# Tompkins County ADA Transition Plan - 2017

**Project:** Tompkins County Transition Plan 2017

**Building:** Old Courthouse

**Date:** April 11, 2017

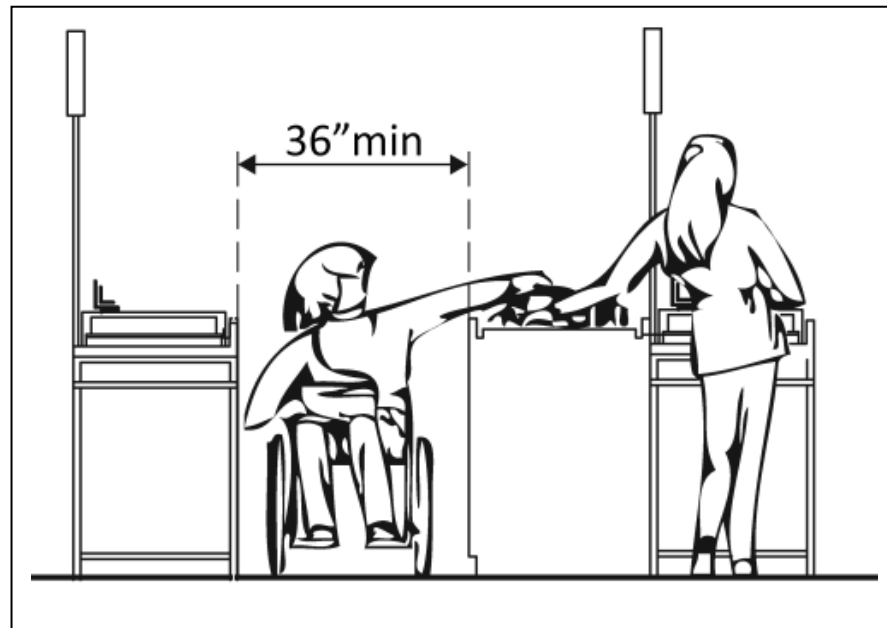
<b>1.25</b>	If the handrail gripping surface is circular, is it no less than 1 ¼ inches and no greater than 2 inches in diameter? [505.7.1]	Yes Measurement: 1 ½"	
<b>1.26</b>	Is the handrail gripping surface non-circular: If Yes, Is the perimeter no less than 4 inches and no greater than 6¼ inches? Is the cross section no greater than 2¼ inches? [505.7.2]	No	
<b>1.27</b>	Does the handrail:  Extend at least 12 inches horizontally beyond the top and bottom of the ramp? Return to a wall, guard, or landing surface? [505.10.1]	Yes  Measurement: 32"  Yes	
<b>1.28</b>	To prevent wheelchair casters and crutch tips from falling off: Does the surface of the ramp extend at least 12 inches beyond the inside face of the handrail? [405.9.1, 405.9.2]	Yes	Ramp has an integral curb.

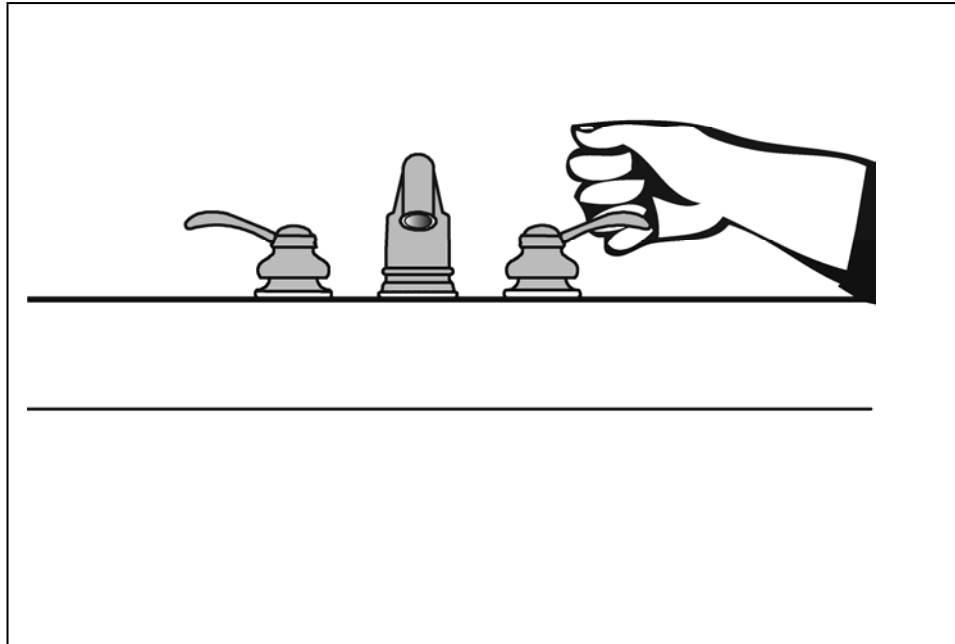
<p><b>2.44</b></p>	<p>Is there a clear floor space at least 30 inches wide by at least 48 inches long for a forward or parallel approach? [305.3]</p> <p>Are the operable parts no higher than 48 inches above the floor?*[309.3, 308]</p>	<p>Yes</p> <p>Yes</p>	
<p><b>2.45</b></p>	<p>Can the control be operated with one hand and without tight grasping, pinching, or twisting of the wrist? [309.4]</p>	<p>Yes</p>
